MILLSTONE NUCLEAR POWER STATION, UNIT NO. 3

AMENDMENT TO FACILITY OPERATING LICENSE

Amendment No. **164**

ATTACHMENT TO LICENSE AMENDMENT NO. 164

FIGURE 3.1-1

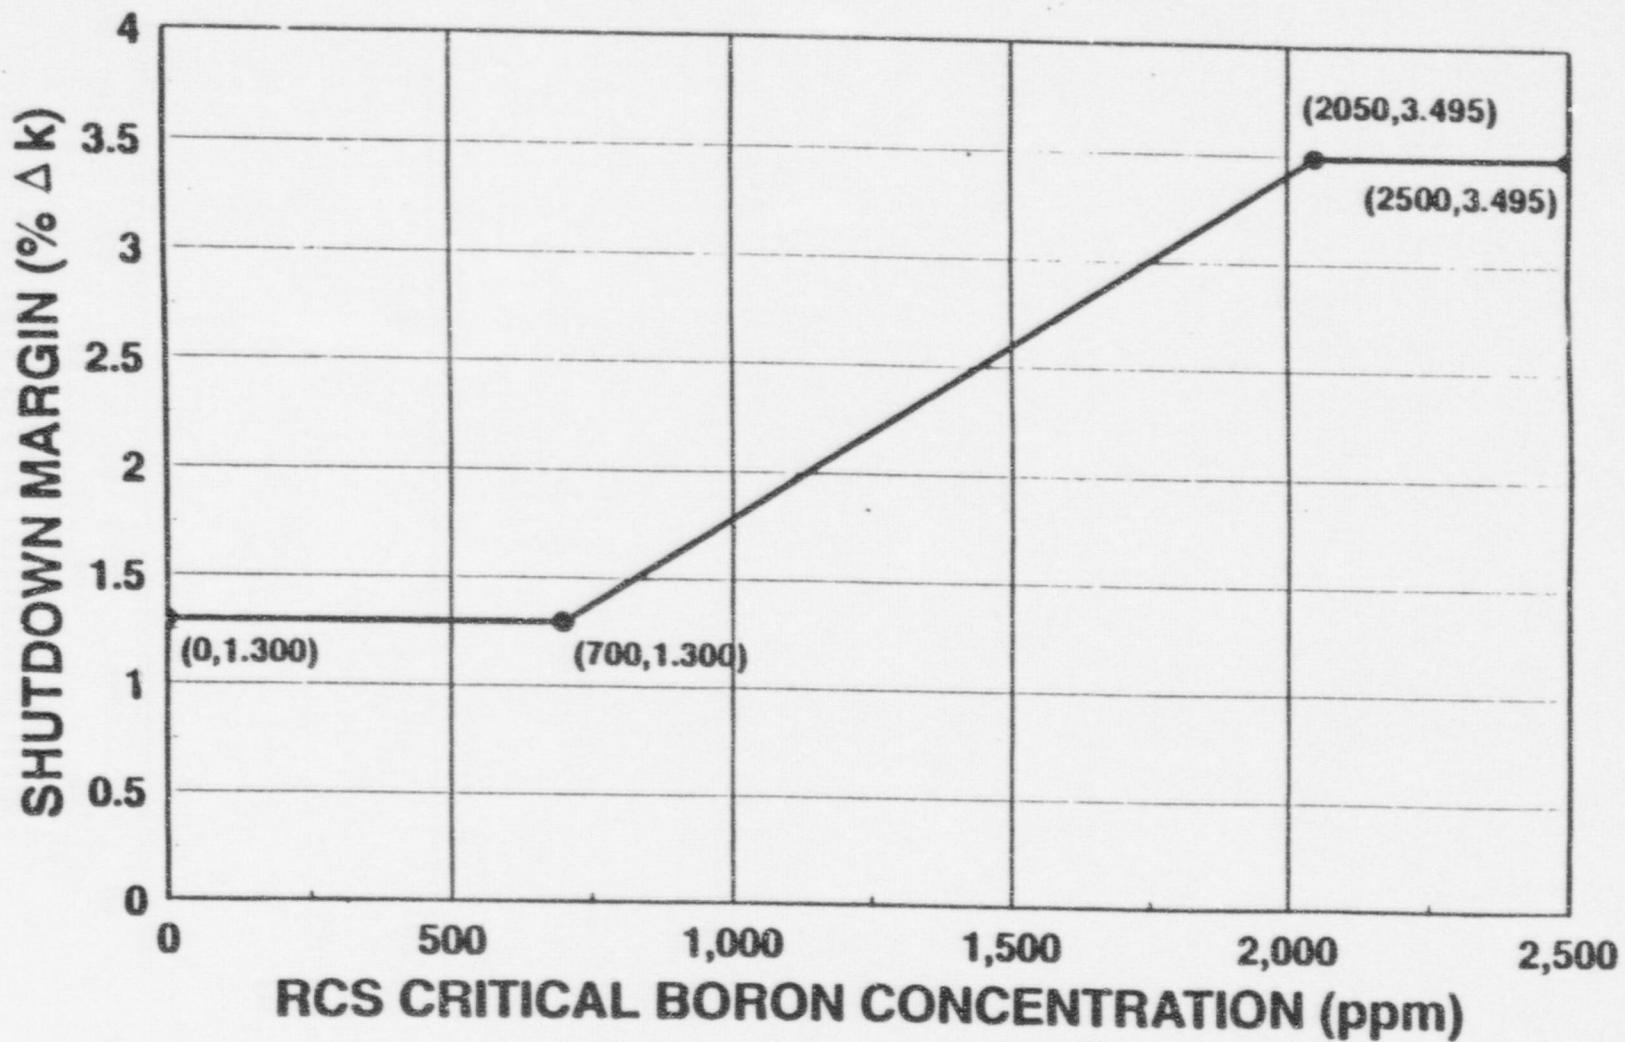
3.1.1.1.2 The SHUTDOWN MARGIN shall be greater than or equal to the limits shown in Figures 3.1-1, 3.1-3 and 3.1-4 for four loop operation and in Figure 3.1-2 for three loop operation.*

FIGURE 3.1-4

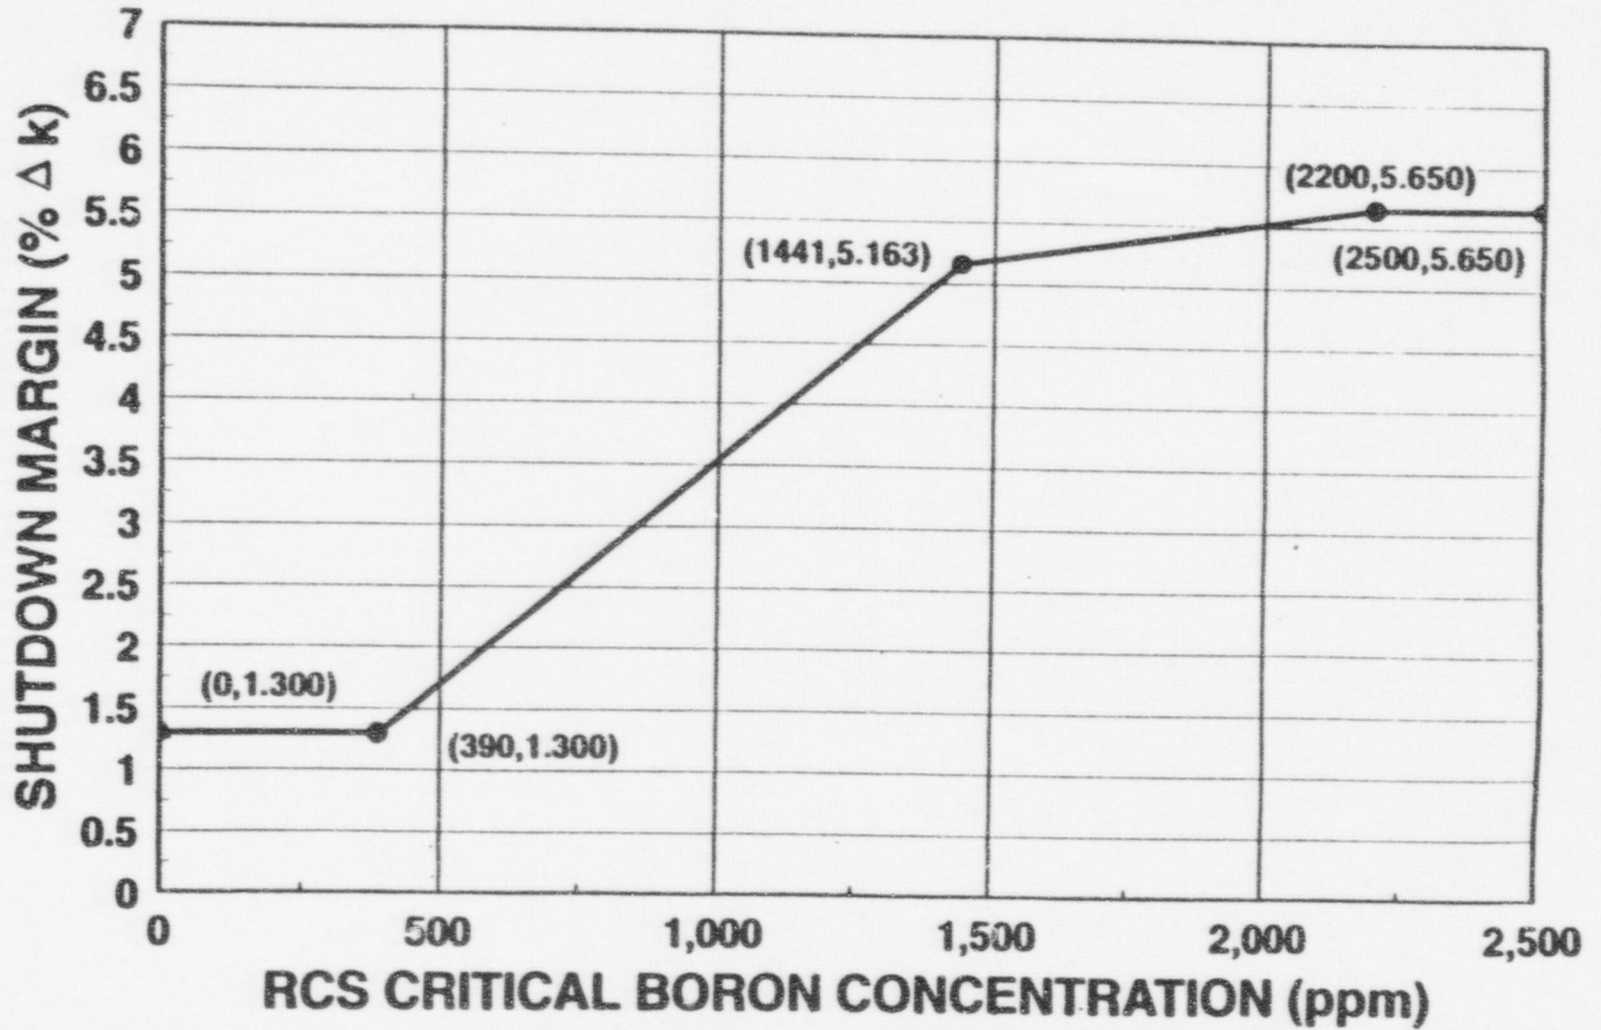
- a) the limits shown in Figure 3.1-5* or
- b) the limits shown in Figure 3.1-4*, with the chemical and volume control system (CVCS) aligned to preclude reactor coolant system boron concentration reduction.

FIGURE 3.1-5
REQUIRED SHUTDOWN MARGIN FOR MODE 5 WITH RCS LOOPS NOT FILLED

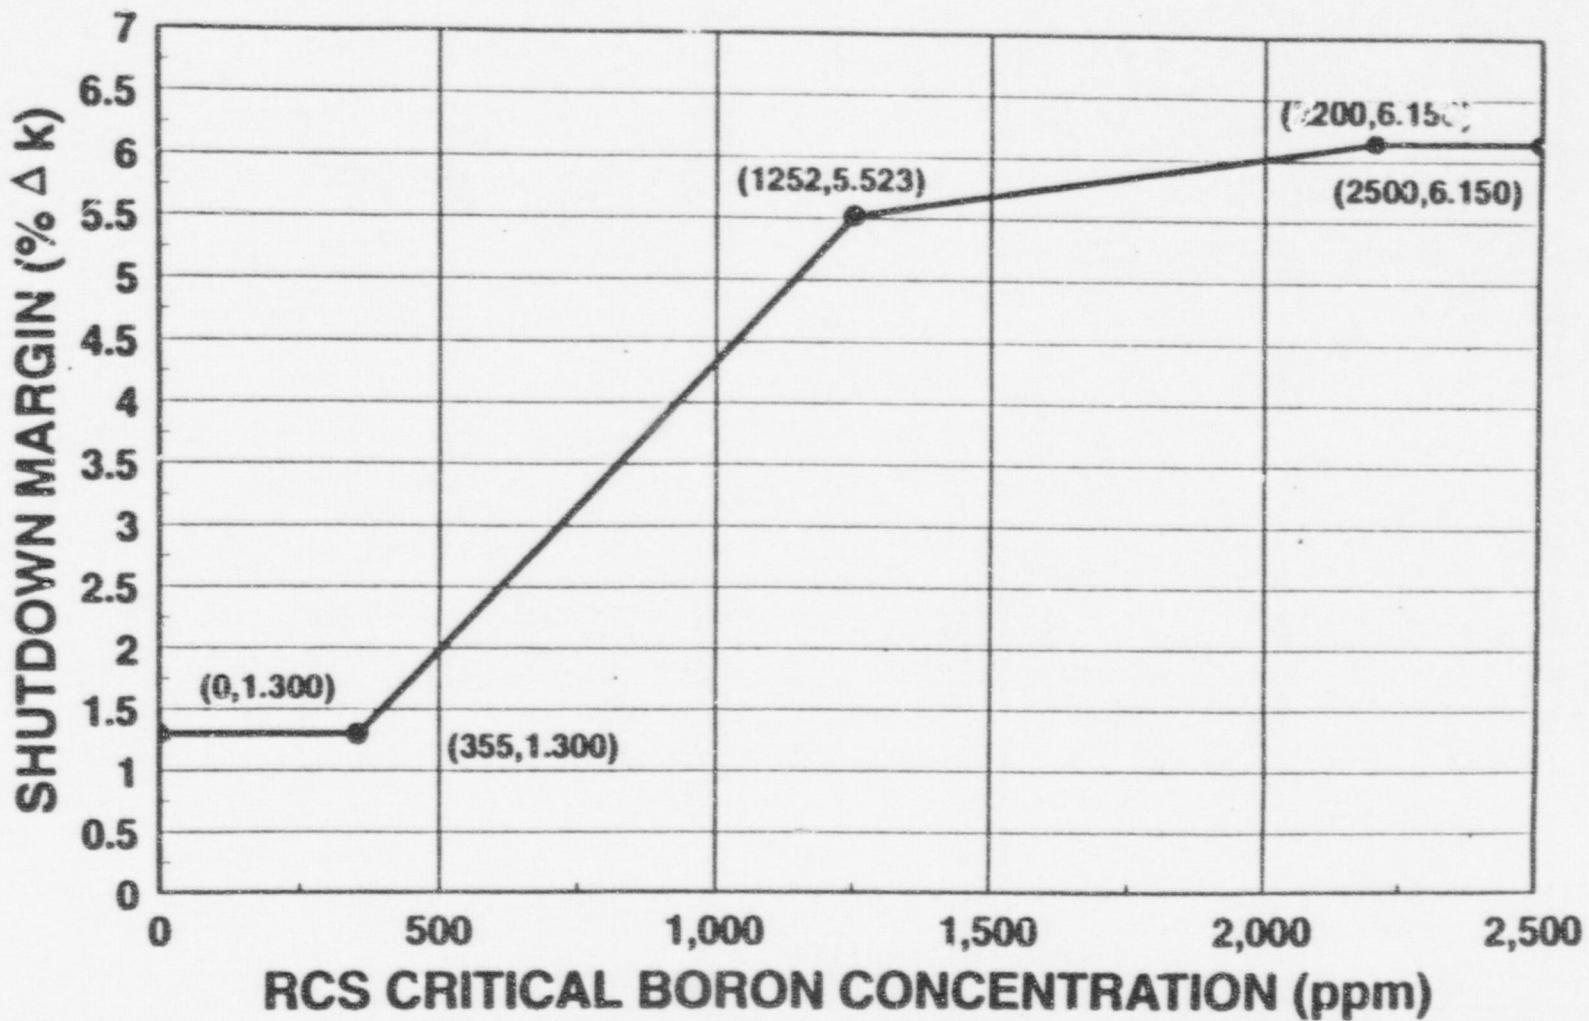
- a. With the SHUTDOWN MARGIN less than the above, immediately initiate and continue boration at greater than or equal to 33 gpm of a solution containing greater than or equal to 6600 ppm boron or equivalent until the required SHUTDOWN MARGIN is restored.
- b. With the CVCS dilution flow paths not closed and secured in position in accordance with Specification 3.1.1.2(b), immediately close and secure the paths or meet the limits shown in Figure 3.1-5.
